PART A: Comments i-250, i-251(Page 136 Line 20) Executives Summary

Comment i-251 (Page 136 Line 20).

PART B: Comment i-254 (Page 136 Line 11).

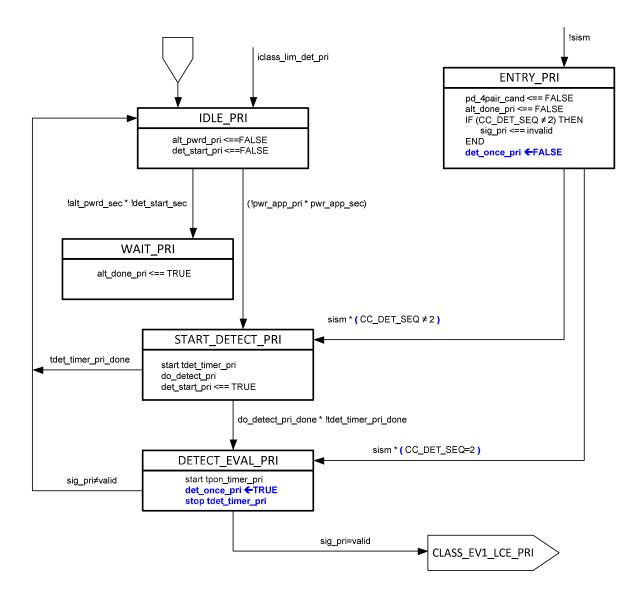
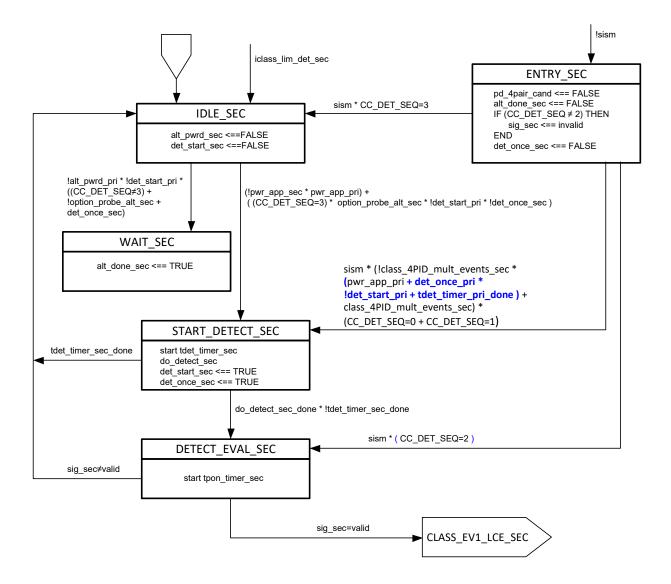
If Primary fails to powerup, the Primary state machine returns back to IDLE_PRI. As a result, pwr_app_pri variable will remain in FALSE, and the secondary state machine won't be able to exit from ENTRY_SEC i.e. will be stuck there.

The straightforward way to handle this problem is to enable moving to START_DETECT_SEC from ENTRY_SEC, also if primary performed detection at least once and is now in IDLE_PRI state which prevents stuck at ENTRY_SEC. This solution requires the addition of new variable det_once_pri (the current draft has only det_once_sec) which is required also by other comments that all related to each other (e.g. to allow the possibility to do cycles of detection + class probe events on primary and secondary.

When class_4PID_mult_events_sec=FALSE, and CC_DET_SEQ=0 is TRUE or CC_DET_SEQ=1 is TRUE, If START_DET_PRI exit to IDLE_PRI due to tdet_timer_pri_done, the pwr_app_pri will remain in FALSE which won't allow exiting from ENTRY_SEC to START_DETECT_SEC and the secondary state machine remain stuck in ENTRY_SEC.

Note: Even if we did detection before tdet_timer_pri is expired, we will get tdet_timer_pri_done anyway at some time. There is missing stop timer assignment.

CC_DET_SEQ=3 for dual-signature PD is currently used in the state machine by the condition: (!pwr_app_sec * pwr_app_pri) which means that we need clarify what is staggered detection for single-signature and dual-signature.

The 2nd issue is the stuck in ENTRY_SEC as explained above.

```
sism * ((!class_4PID_mult_events_sec * ( pwr_app_pri + det_once_pri * !det_start_pri + tdet_timer_pri_done ) ) + class_4PID_mult_events_sec) * (CC_DET_SEQ=0 + CC_DET_SEQ=1).
```

1. Add the following variables to 145.2.5.4

det_once_pri

This variable indicates if the PSE has probed the Primary Alternative at least once, when entering to DETECT_EVAL_PRI. Values:

FALSE: The PSE has not probed on the Primary Alternative since entering the Primary Alternative state diagram.

TRUE: The PSE has probed the Primary Alternative at least once since entering the Primary Alternative state diagram.

2. Make the following changes to the state machine:
